# Release Notes: xD3 Firmware V1.3

The xD3 module firmware update applies to all EXS models:

EXS-1 Mk2, EXS-2 Mk2, EXS-3, EXS-3CY, EXS-5.

New Feature: Delete Kit

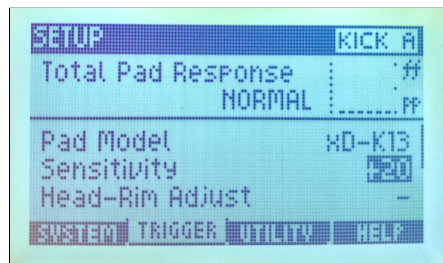
A **Delete Kit** function has been added to the SETUP │ UTILITY menu.

The Delete Kit screen displays the list of installed kits excluding the five factory preset kits.

A listed kit can be selected and deleted from the module.

The currently loaded kit cannot be deleted.

Change: Trigger Sensitivity Setting Range

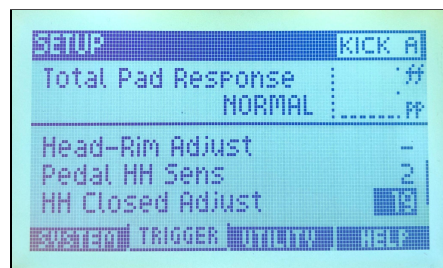
In the SETUP | TRIGGER menu, the range of the **Sensitivity** setting has been modified.

The new range for all pads is -10 to +20.

The extended value range assists EXS-5 users in setting the sensitivity for the xD-K13 and xD-P13M pads.
